PCN Number: CC152204A (Revised 06/29/15) Notification Date*: June 04, 2015
See Updates in Blue Font

Title: Revision of POR (Power On Reset) Circuit of AT25xxxB Automotive grade Serial EEPROMs	
Product Identification: All Packages of the Automotive Temperature Grade (-40C to +125°C) AT25xxxB SPI Serial EEPROMs	
Reason for Change: ☐ Material / Composition ☐ Processing / Manufacturing ☒ Design / Firmware ☒ Datasheet ☐ Manufacturing Location ☒ Quality / Reliability ☐ Logistics ☐ Other:	
Change Description: As part of Atmel's ongoing effort to improve product performance, Atmel has modified the POR (Power On reset) circuit on all AT25xxxB Series SPI interface Automotive Grade Serial EEPROMs. This change is implemented to support those applications which require faster reset at cold temperatures and some other applications which cannot comply with current datasheet recommendation to power down to, and remain at 0.0V for at least 500ms before beginning the next power up sequence. The new devices offer a modified reset response time as defined below: Device Reset Description and Purpose The main purpose of a POR circuit is to ensure that the device will initialize into the correct state u

Appendix – PRODUCT IDENTIFICATION**Package Marking – Current AT25xxxB versus New Modified Devices****Current AT25xxxB Devices – Package Marking****AT25080B, AT25160B, AT25320B, AT25640B, AT25128B, and AT25256B:
Automotive Package Marking Information**

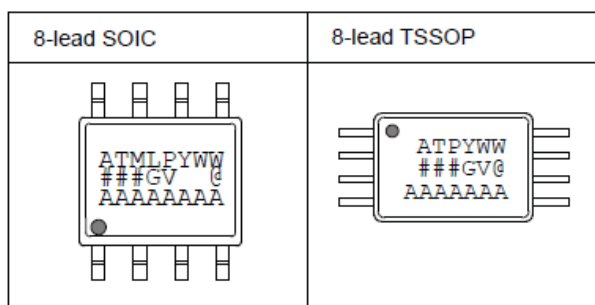
New modified part numbers use "GV" suffix for the device revision (for example, AT25640B-SSPD-T changes to AT25640B-SSPDGV-T). In addition, all modified devices will be identified a "GV" package marking. The top package marking format for the new modified devices versus current part numbers are shown in Appendix.
